**Subject** Change Order No. 2, Lease-Leaseback Contract – Cahill Contractors LLC– Fremont High School Modernization Project– Division of Facilities Planning and Management

# CHANGE ORDER

| Project: | Fremont Modernization |

DESCRIPTION OF AGREED CHANGES IN WORK OR CONTRACT (refer to attached pages or incorporated documents, if necessary):
Phase I & II: Various Change Requests PCOs 2- 12

Sheet
E2.01

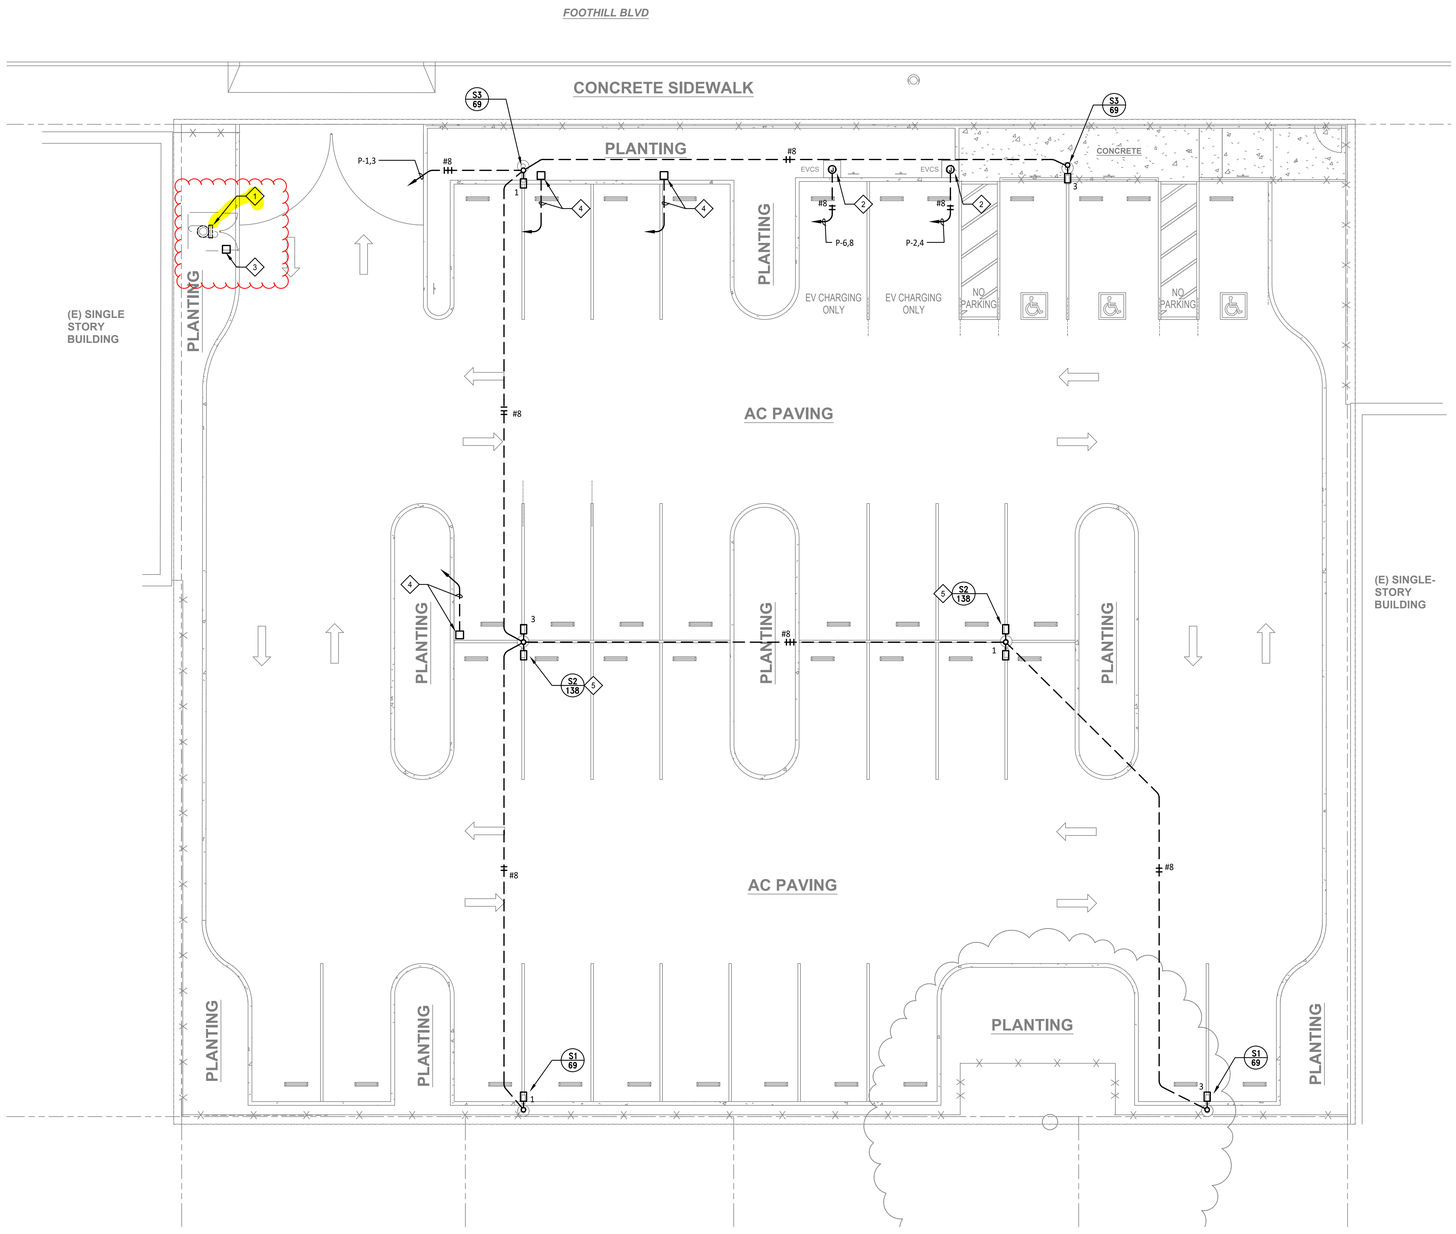
Sheet note 1 on E2.01 shows that we are to pull power for the parking lot from the existing parking lot meter and panel. Sometime between Cahill walking the job during project award, and now, the panel has been vandalized. As shown in the photos attached on SK-02, the panel is on the ground, the meter is gone, and the conduit feeding the panel has been removed.

Sheet
E2.01

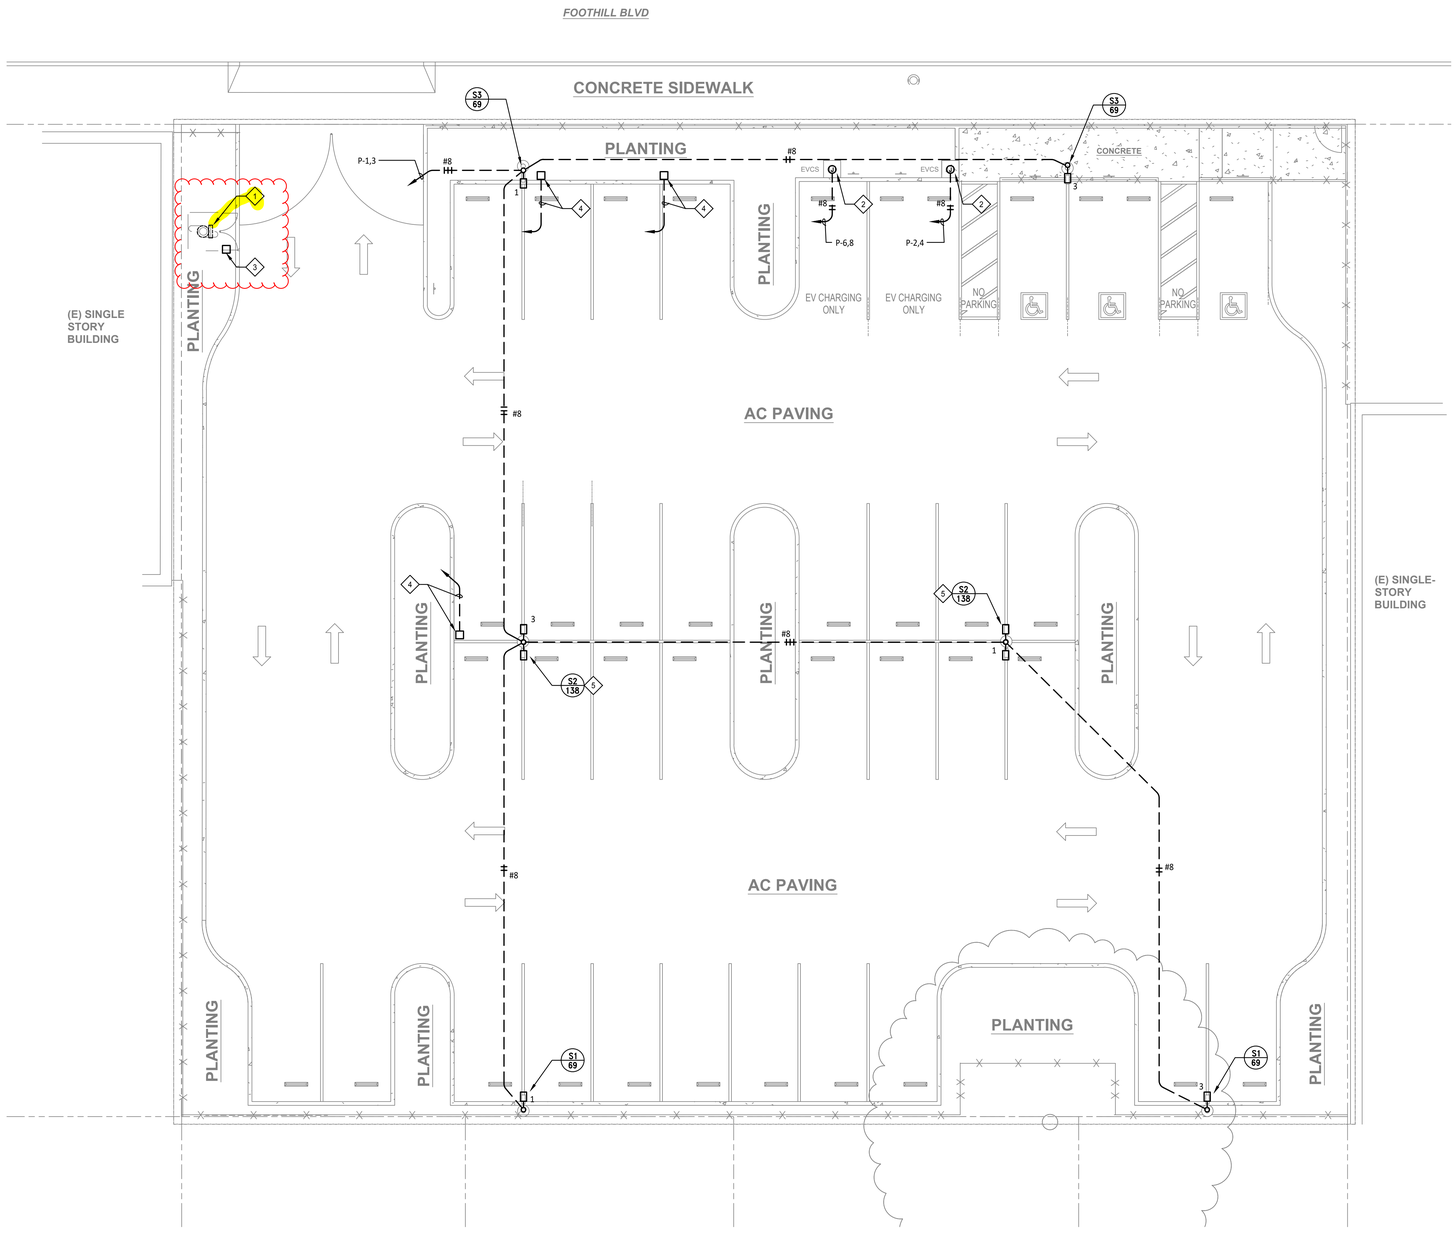
Sheet note 1 on E2.01 shows that we are to pull power for the parking lot from the existing parking lot meter and panel. Sometime between Cahill walking the job during project award, and now, the panel has been vandalized. As shown in the photos attached on SK-02, the panel is on the ground, the meter is gone, and the conduit feeding the panel has been removed.

Sheet
2-L8.01

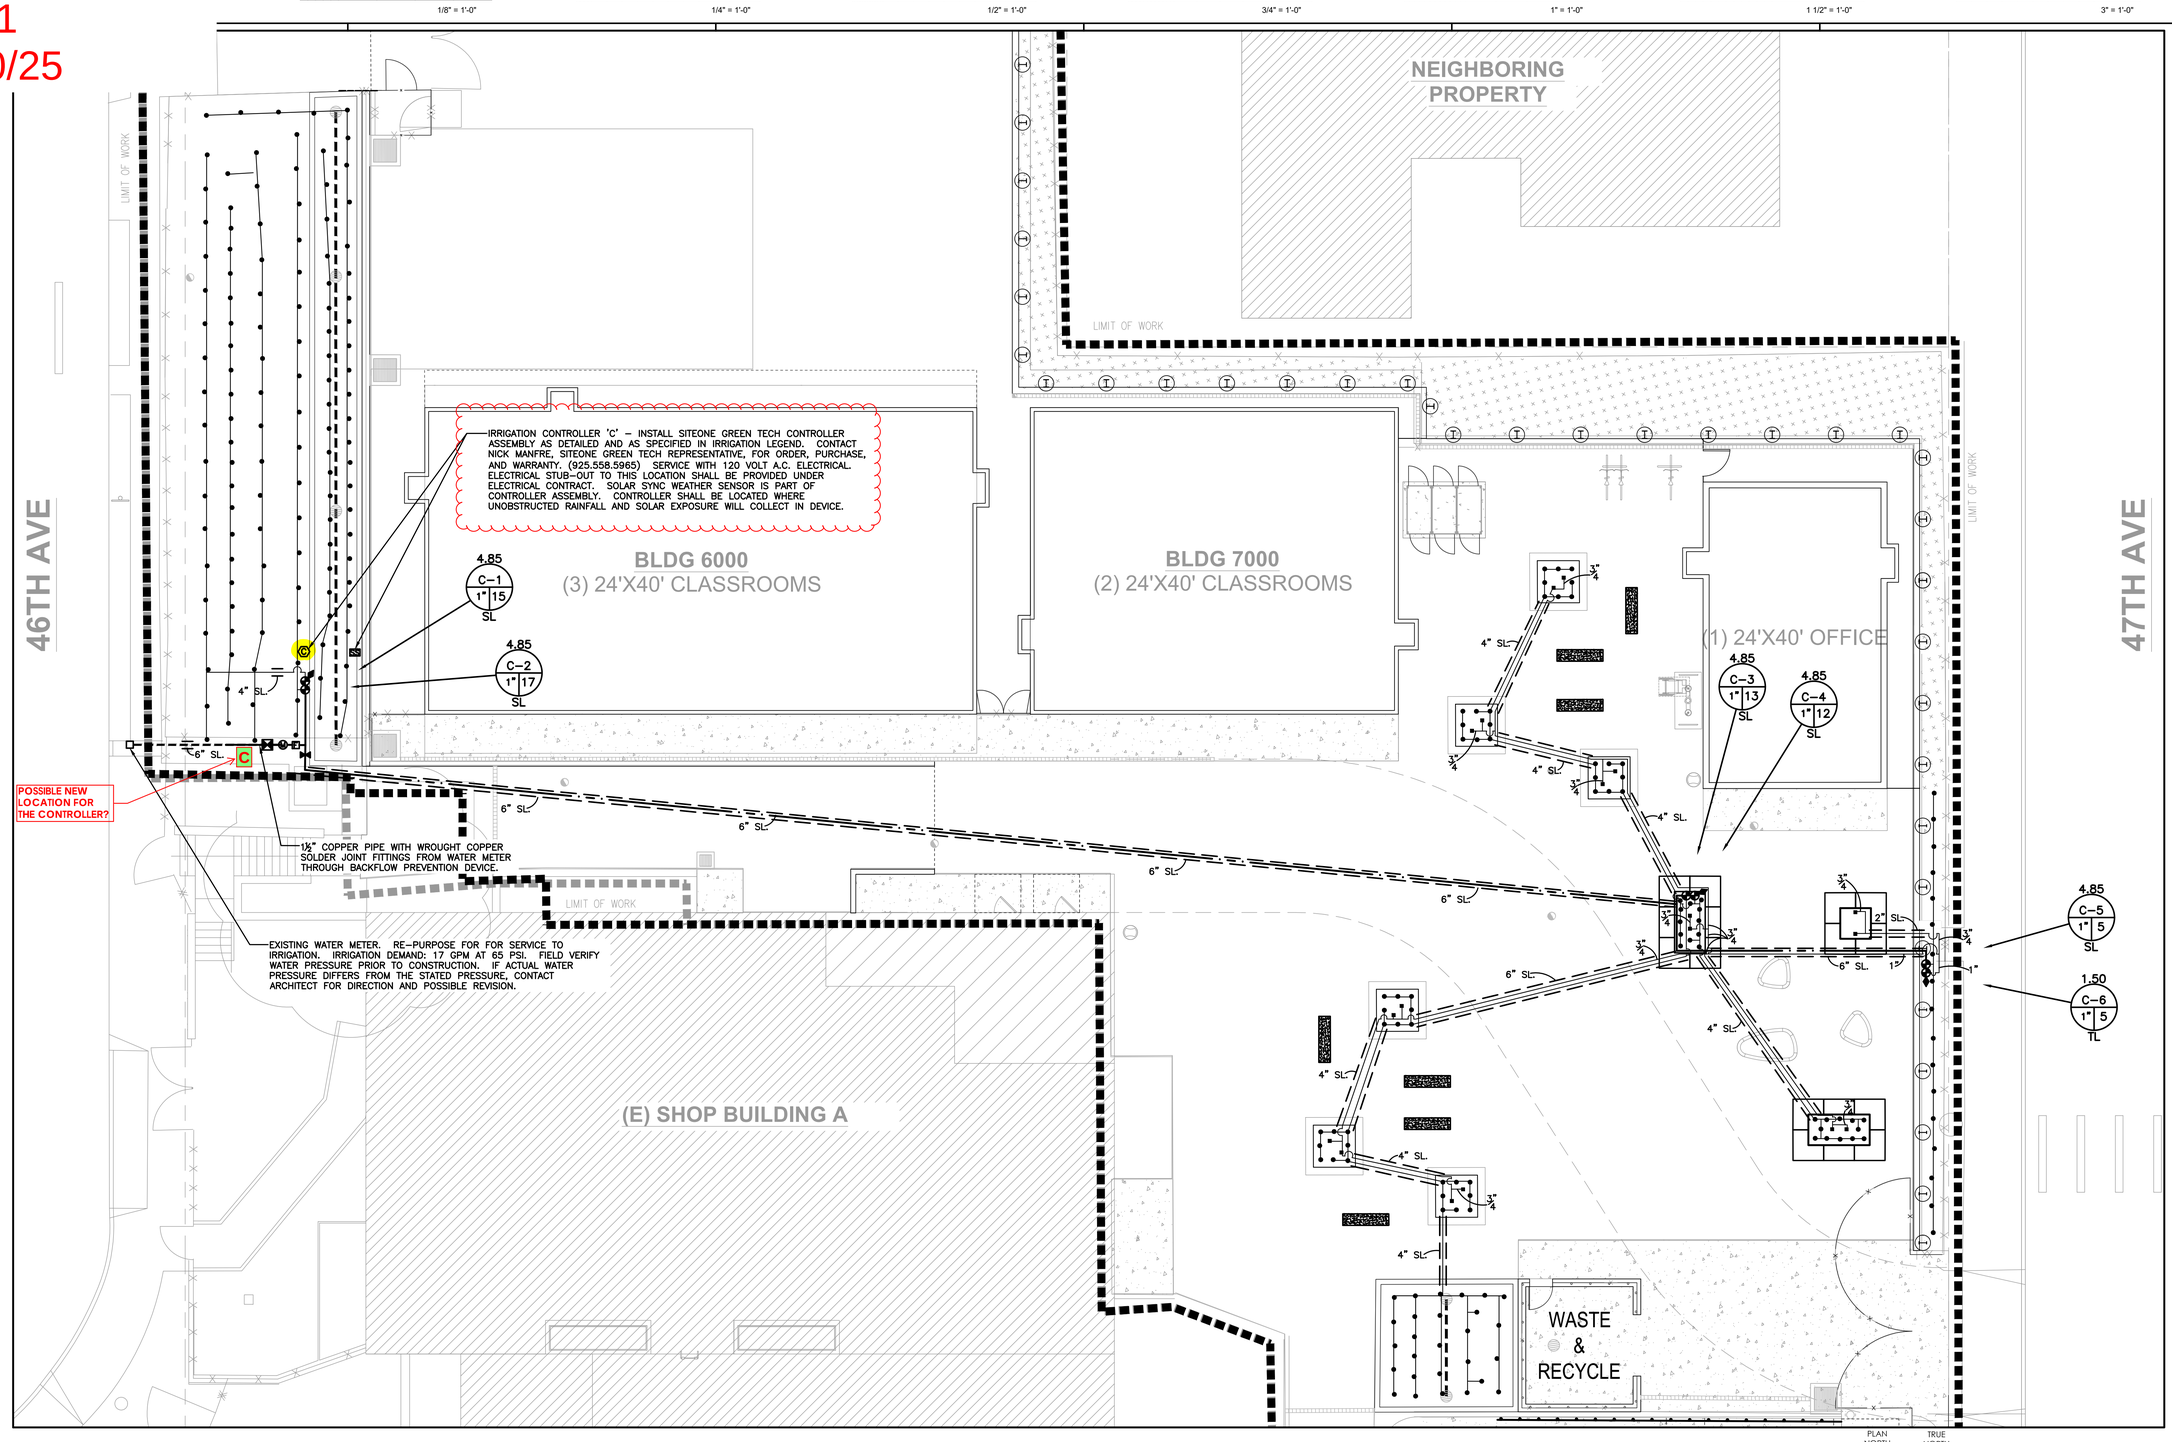
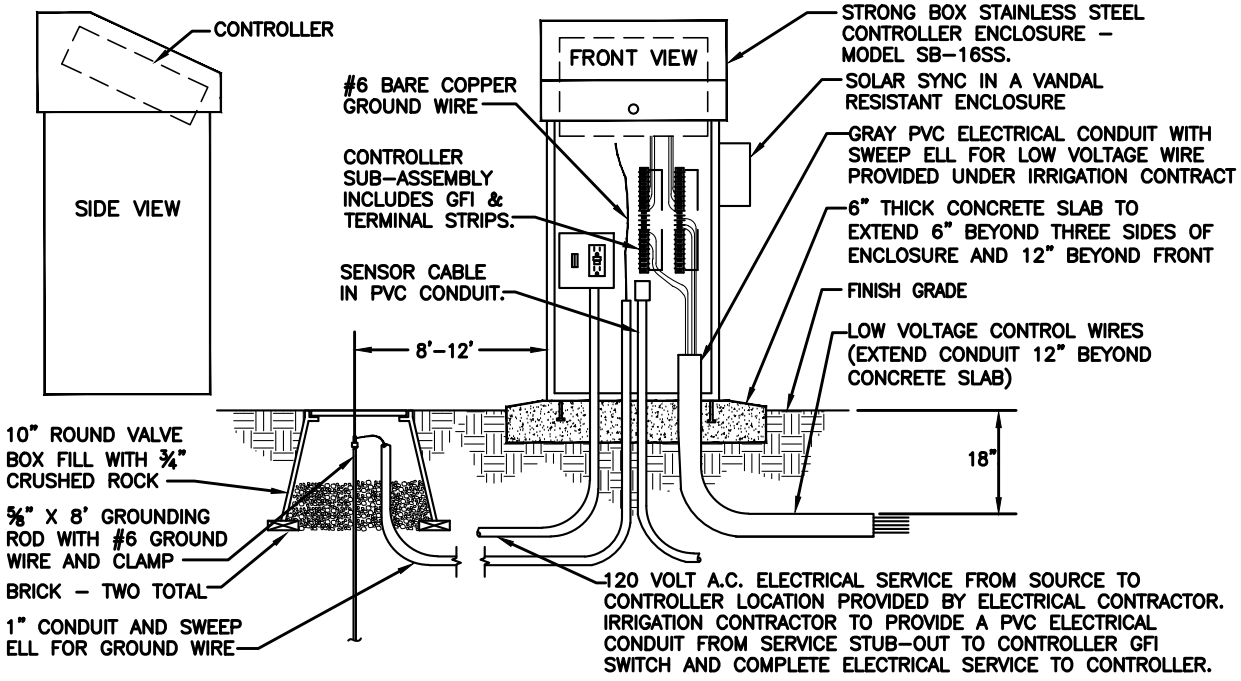
2-L8.01 calls for an irrigation controller to be installed in the bioretention planter which is to be connected to 120 Volt A.C. electrical. No information is provided for the controller on the electrical drawings.
